Re: Case No. PU-24-361
Basin Electric Power Cooperative - Leland Olds Station to Tande 345-kV Transmission Line Project

99 PU-24-361 Filed 09/26/2025 Pages: 4
Certification Relating to Modification of Site Plan

Leland Olds-to-Tande 345kV Transmission Project

DASK Area Update - Figure 1

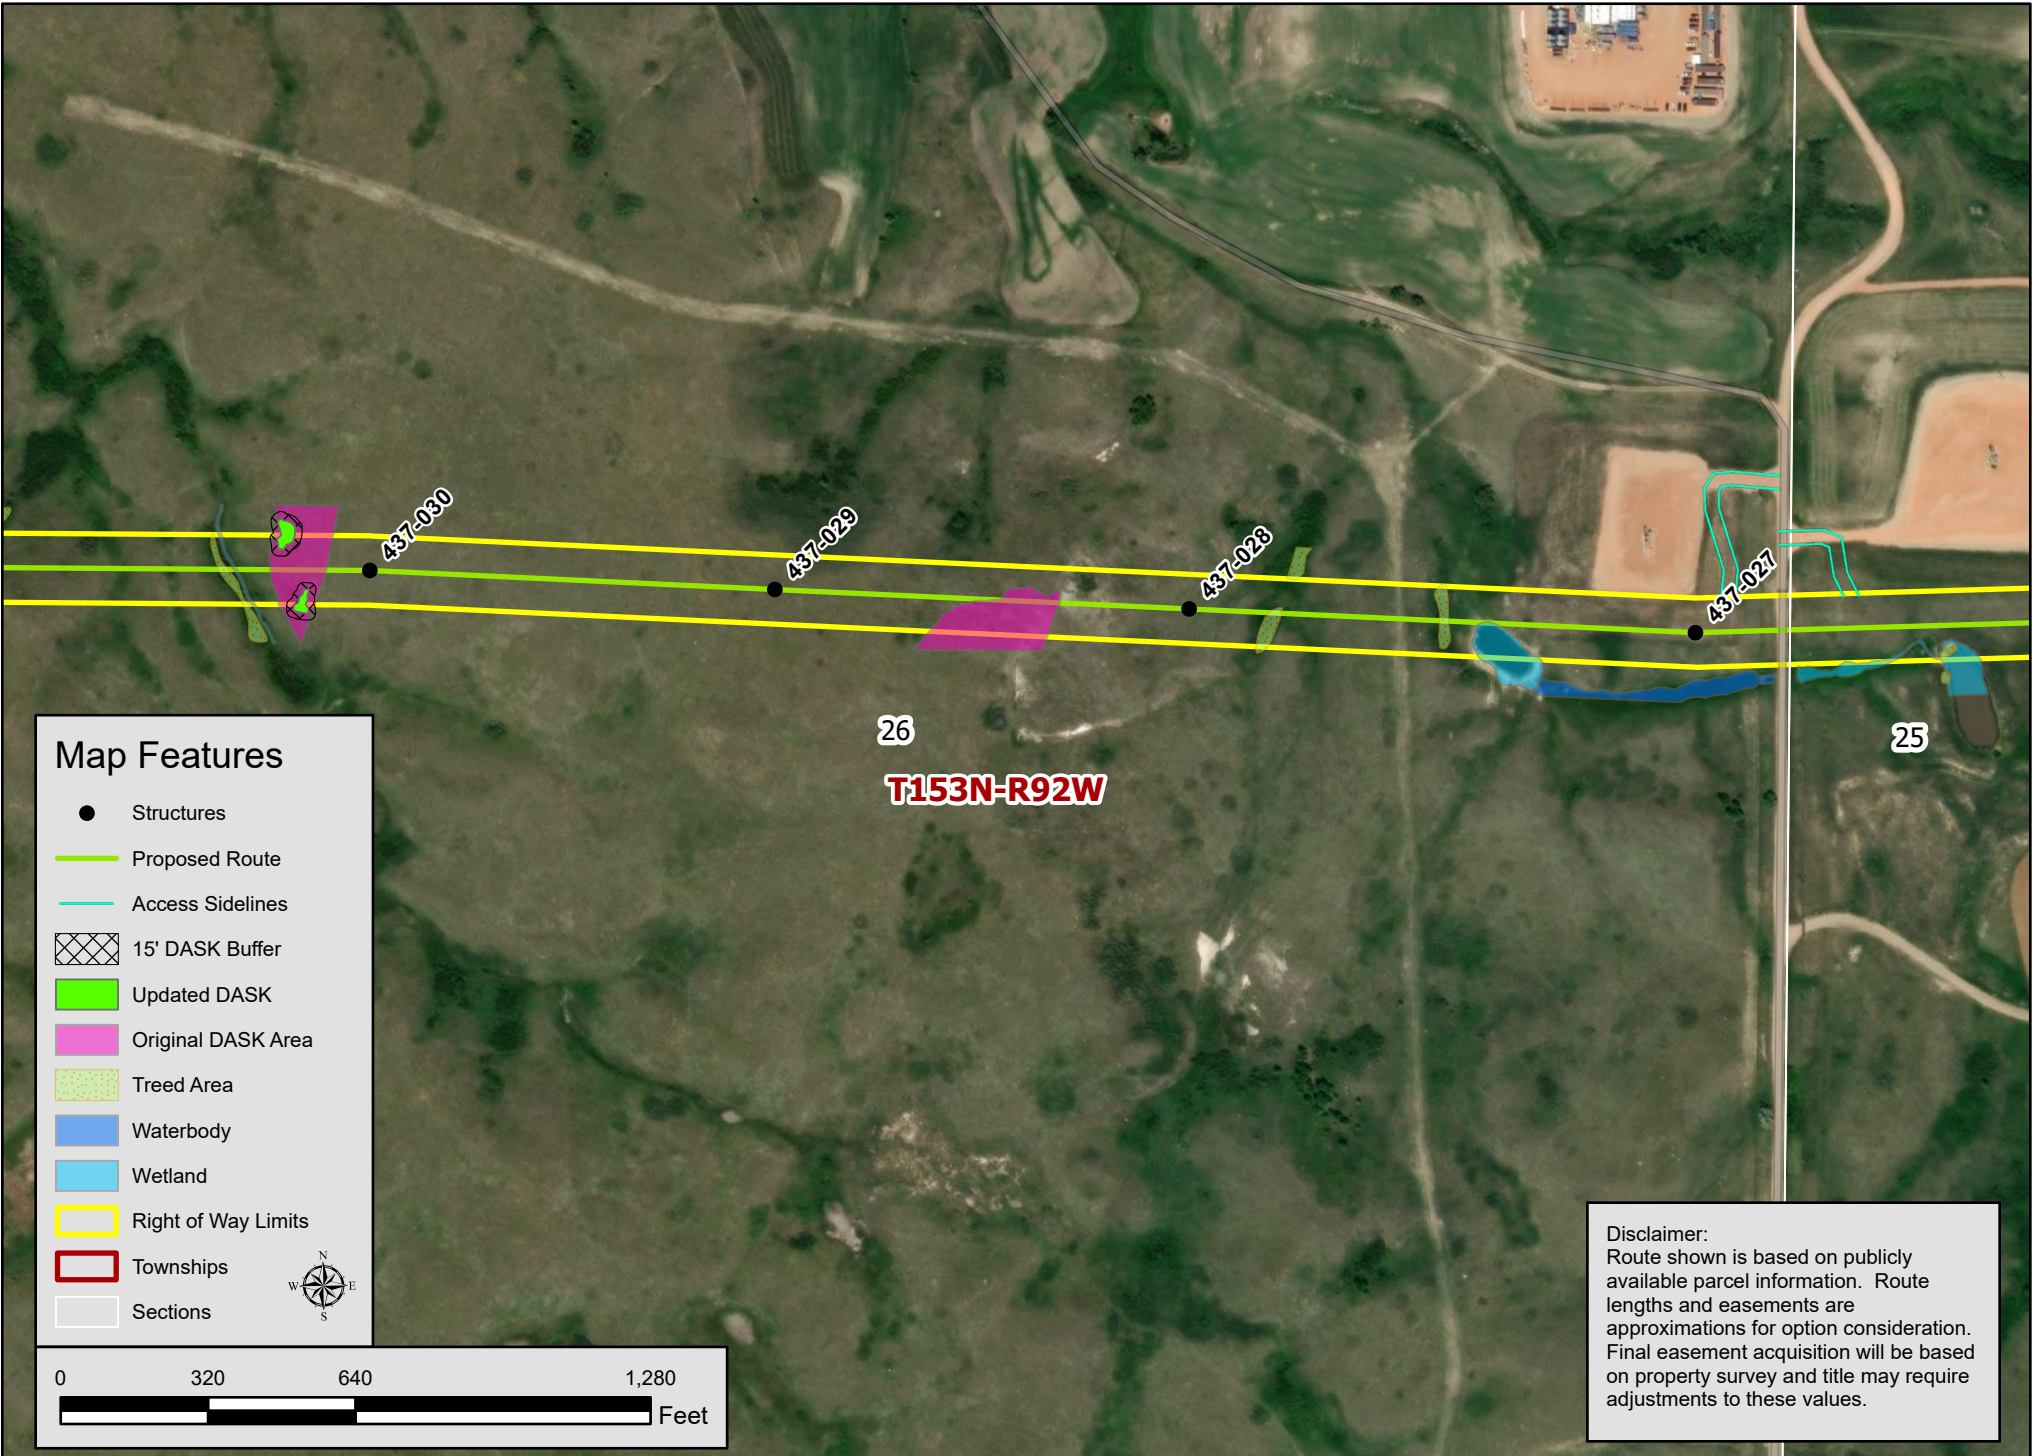
In accordance with item 32 of the Certification Relating to Order Provisions, please accept this site plan modification notification for Basin Electric Power Cooperative's (Basin Electric) Leland Olds Station to Tande 345-kV Transmission Line Project (PU-24-361). For structures 437-028 to 437-030, Basin Electric has had to look at alternative access options. Access from the west is limited by an oil well pad, wetland, and steep topography. Access from the east is limited due to the presence of a Dakota skipper habitat area that spanned the entire right-of-way (See **Figure 1**). This Dakota skipper habitat area was delineated by Western EcoSystems Technology, Inc. (WEST) in 2023. Understanding that WEST generally is conservative with these Dakota skipper habitat areas and can be more inclusive when mapping them, Basin Electric employed WEST to conduct a more thorough review of the area to help refine the habitat locations. Per **Figure 2**, WEST narrowed the area to two smaller habitat locations. Also included in **Figure 2** is a self-imposed additional 15-foot buffer around these two locations and the proposed access through them.

This access will stay within the established corridor, as reflected in the Certificate of Corridor Compatibility Number 237. Like all Dakota skipper habitat areas within the established corridor, Basin Electric will fence the areas to avoid any vehicle impacts. These two areas will also continue to be included in the Dakota skipper flight period buffers, established in accordance with the United States Fish and Wildlife Service, where a 500-meter avoidance buffer will be placed around these habitats and no construction will occur during the flight period.
